Change of terminal layout

Product Change Notification				UST 1206 20A/25A Terminal improvement				
owner	creation date	release date	released by	change order no	rev	page	D10-018-391	
ganderka	06.04.2018	13.04.2018	haeckima	2015154	В	1 of 1

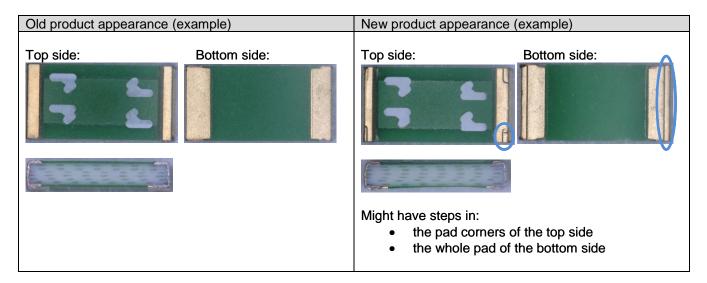
3 Detailed description of change

Change of terminal layout for improved burr reduction handling

Form	Yes	Change of terminal section appearance
Fit	No	No change for dimension
Function	No	No change in function, datasheet specification remain as before.
Manufacturing	No	No change for manufacturing site
Label	No	No change on label
Packaging	No	No change in packaging
